ADDENDUM

ADDENDUM #2

24C3, Warehouse Walk-in Freezer and Refrigerator

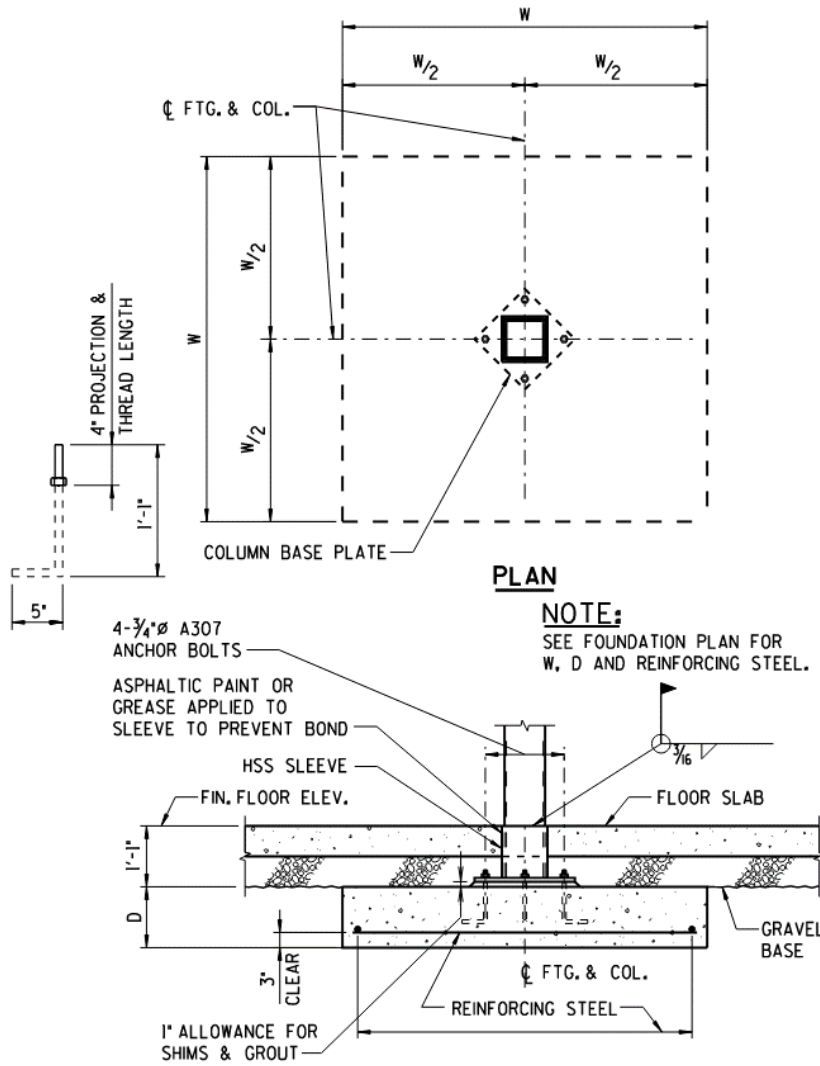
Only the columns on column line B are the A columns – the rest of the interior spreads in your cold box area are the B columns per the following table:

COLUMN FOOTING SECTION (F47)
S-302,303

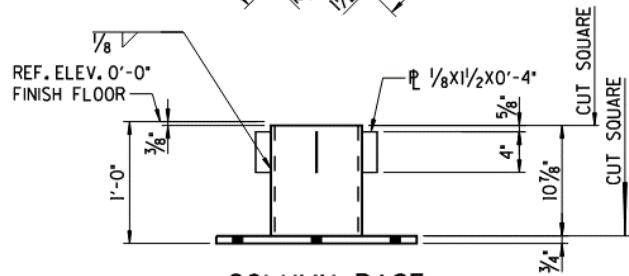
Also, here is the cut indicating the depth of the footing – looks like 13" below finished slab to the top of the footing.

COLUMN BASE
CB2
 (QUANTITY 75)

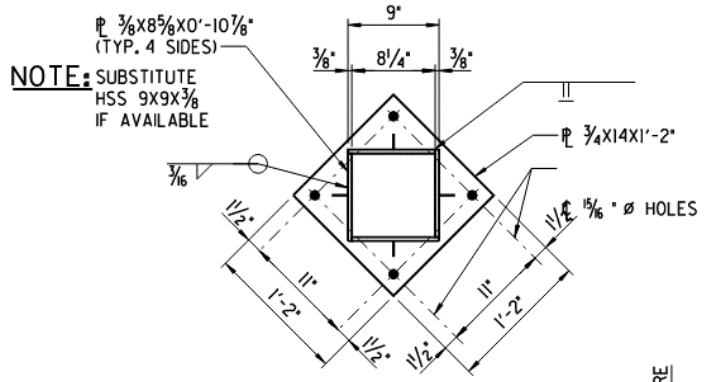
Here are the details for the column base that Jeff indicated would need to be insulated:
